Case No. 12-0126-EL-REN Sunstream-Martin Part1 Staff Interrogatories – Initial Set

Summary: Reply Reply to question regarding system location for the Sunstream-Martin solar system. electronically filed by Mr. Marcel Witmer on behalf of Sunstream-Martin Part 1

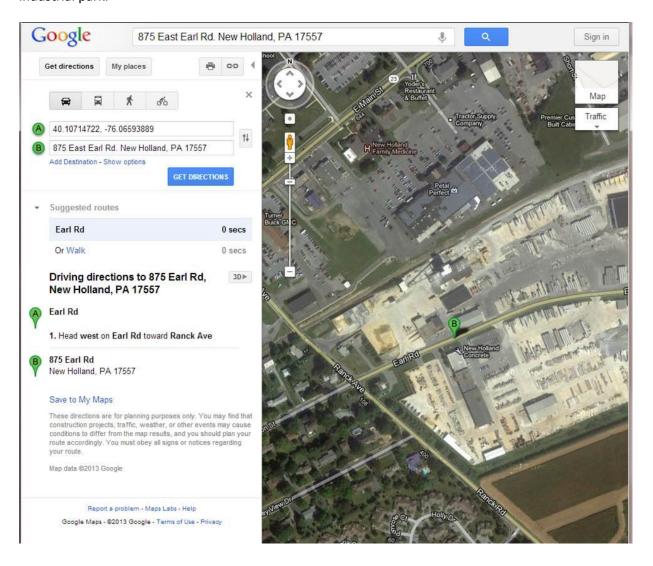
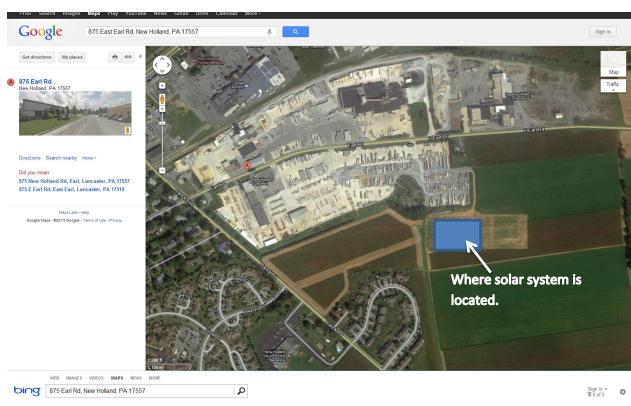
Question 1: In Section G.3 of the application the facility appears to be in an agricultural field but the address and latitude and longitude show the location to be in an industrial park. Please explain the discrepancy.

Answer 1: The facility is indeed in an agricultural field. But the field is adjacent to the industrial park in the pick below. The solar system will be providing electricity for the concrete company located in the industrial park.

Below are a couple different pictures showing where the solar system is located in relation to the address of the company who will be powered by the system and who owns the field where the solar system is located.
